**Re: Rapiscan AIT System Radiation Survey Reporting**

<b>Rapiscan</b> SYSTEMS	<b>Secure 1000 Radiation Emission Measurement</b>	FORM R-0646-1 (Single Pose)
----------------------------	---	--------------------------------

**R-0646-1 Addendum  
(Documentation Errors)**

## 2. Radiation Leakage Measurement: Survey Table. 2

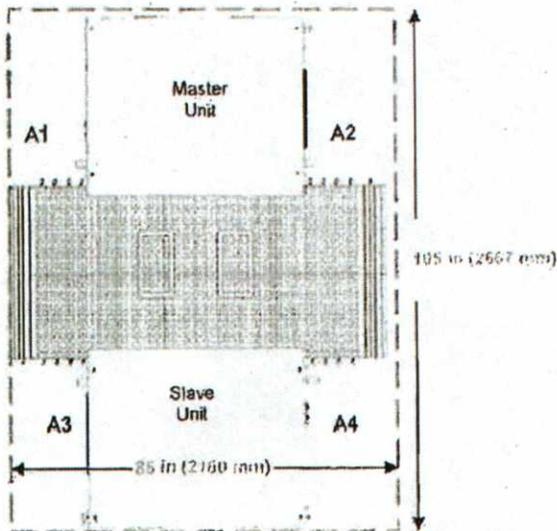
1. TABLE 2: Incorrect presentation of data in Column 3 for Measured Exposure. Indicated value is .1 uRem. The correct value should be 1 uRem.
2. TABLE 2: Incorrect presentation of data in Column 6 for Dose Equivalent. Indicated value is .18 uRem. The correct value should be 1.8 uRem.

The service technician should attend refresher training.

The corrected data indicates this system was operating within expected parameters. No re-survey is required for this system.
